APPLICATION NO.	FILING DATE	FIRST NAMED INVENTOR	ATTORNEY DOCKET NO.	CONFIRMATION NO.
09/172,553	10/14/1998	JAMES E. GREEN	2914.IUS	9441

Office Action Summary

DETAILED ACTION

Fig. 9

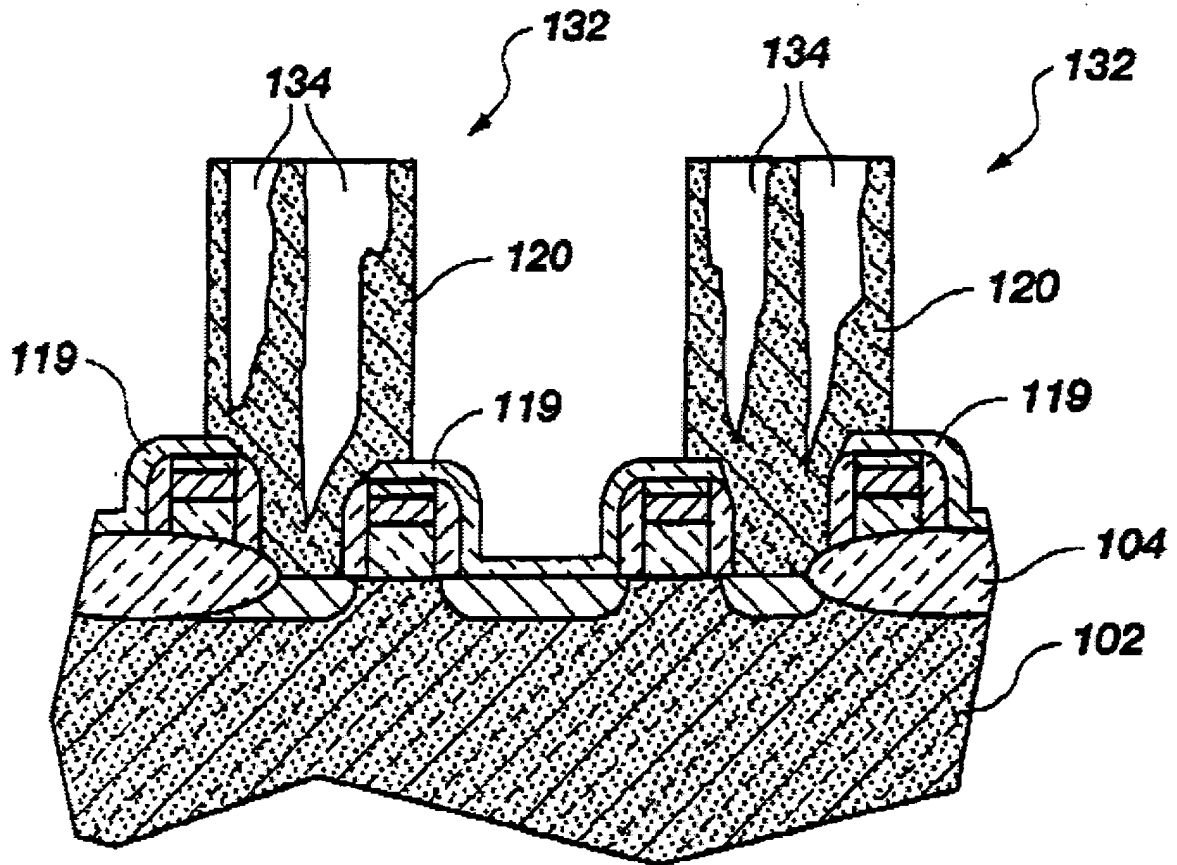
a) With regards to figure 9, what portion of the storage poly 120 constitutes a mesa or web? Also, which portions of the storage poly 120 constitute the top and bottom portions of the mesa or web? In addition, how the depth of the opening or recess 134 is related to the height of the mesa or web? And, please identify at least two contiguous mesas.

Fig. 22

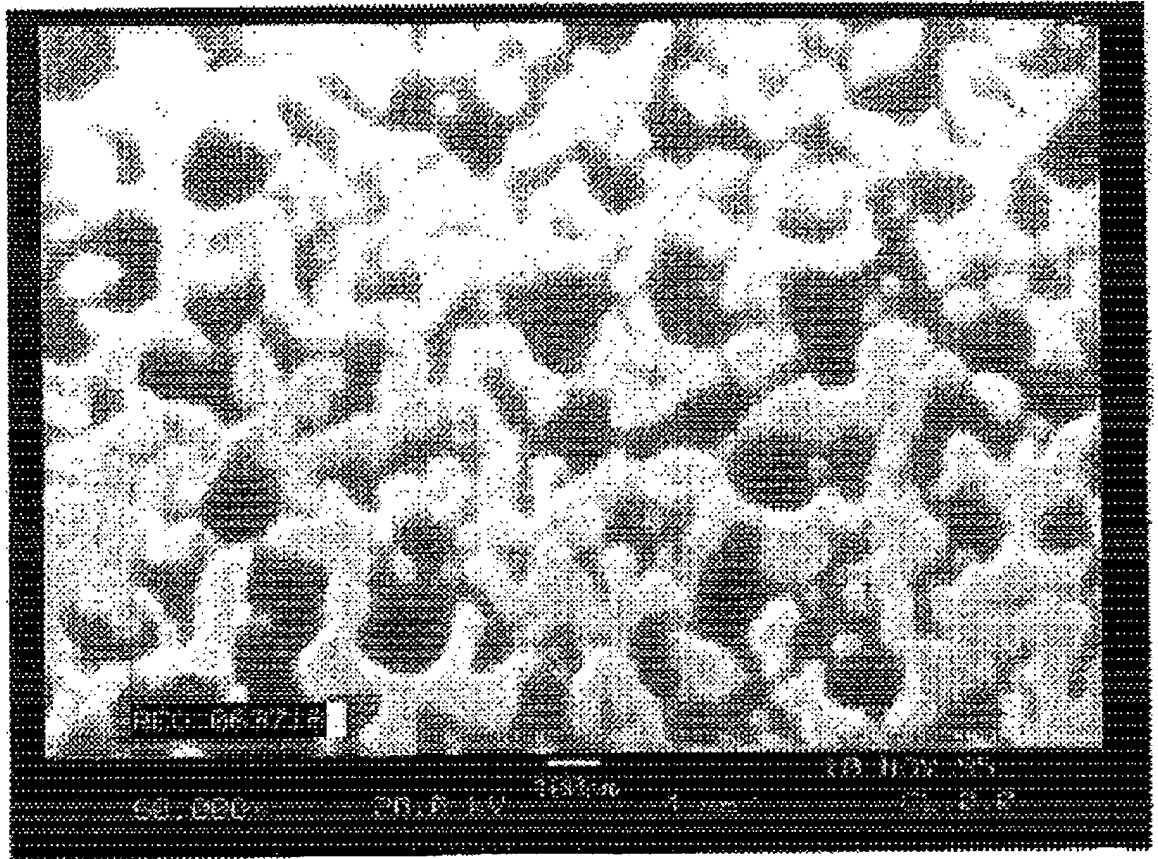
b) With regards to figure 22 (top view), please identify at least two mesas. Also, identify the start and end points of each mesa. And, please identify at least two contiguous mesas.

Fig . 10

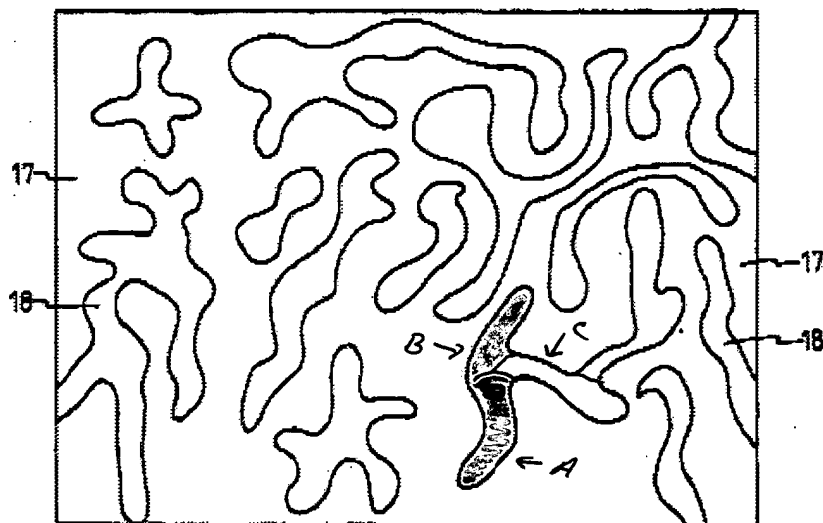
Regarding claims 31-32, Woo et al. teach a semiconductor capacitor storage poly (30) (see figure 2) comprising: downwardly extending recesses (consider the space between the mesas 23 in fig. 2); and a plurality of *contiguous mesas* (23) extending in the X, Y and Z coordinates (see figure 2) and comprising a plurality of contiguous top surfaces (18) (see fig. 10) forming a maze-like structure (see the passages between the mesas 23 in figures 2 or the passages 17 between the top surfaces 18 in fig. 10).

With regards to the terms "contiguous mesas" or "contiguous webs", please refer to figure 10, below, in which mesas or webs A, B and C are shown connected to one another.

F I G . 4 c

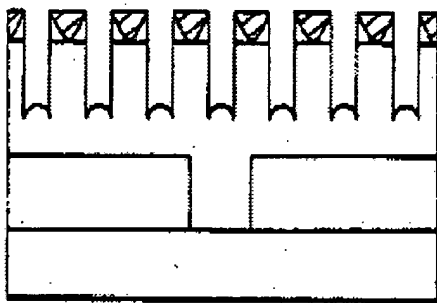
Regarding claims 35 and 43, Jun et al. teaches an intermediate semiconductor capacitor structure (see figure 4c) comprising: a storage poly structure (13) comprising a plurality of contiguous mesas (consider the fingers or columns that include mask 15 and HSG 14 in fig 4c) with recess formed therein (consider the space between the fingers or columns in fig. 4c); a contiguous hemispherical-grain polysilicon (14) over said storage poly structure (13) (see fig. 4c) and a mask (15) over said hemispherical-grain polysilicon layer (14), said recesses (consider the space between the fingers or columns) being exposed through said contiguous hemispherical-grain polysilicon (14) and said mask (15) (see figure 4c).

With regards to the terms "contiguous mesas" or "contiguous webs", please refer to figures 4c and 6c, below. Please note that figure 4c shows shallow recesses that do

not disturb the continuity of the storage poly structure 13. Thus, figure 4c shows storage poly fingers connected throughout in an unbroken sequence.

F I G . 6 c

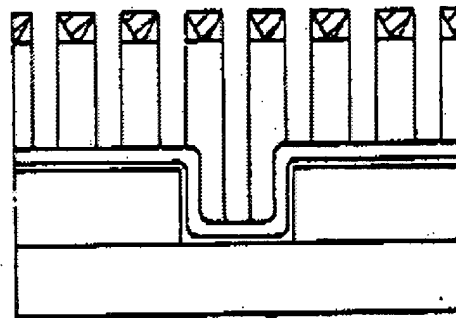
By the contrary, figure 6C shows deep recesses that disturb the continuity of the fingers. Thus, in this case figure 6c does not show contiguous fingers. Therefore, the terms "contiguous mesas" or "contiguous webs" in view of Jun et al. will be define according to figure 4c, in which shallow recesses are provided without disturbing the continuity of the storage poly.
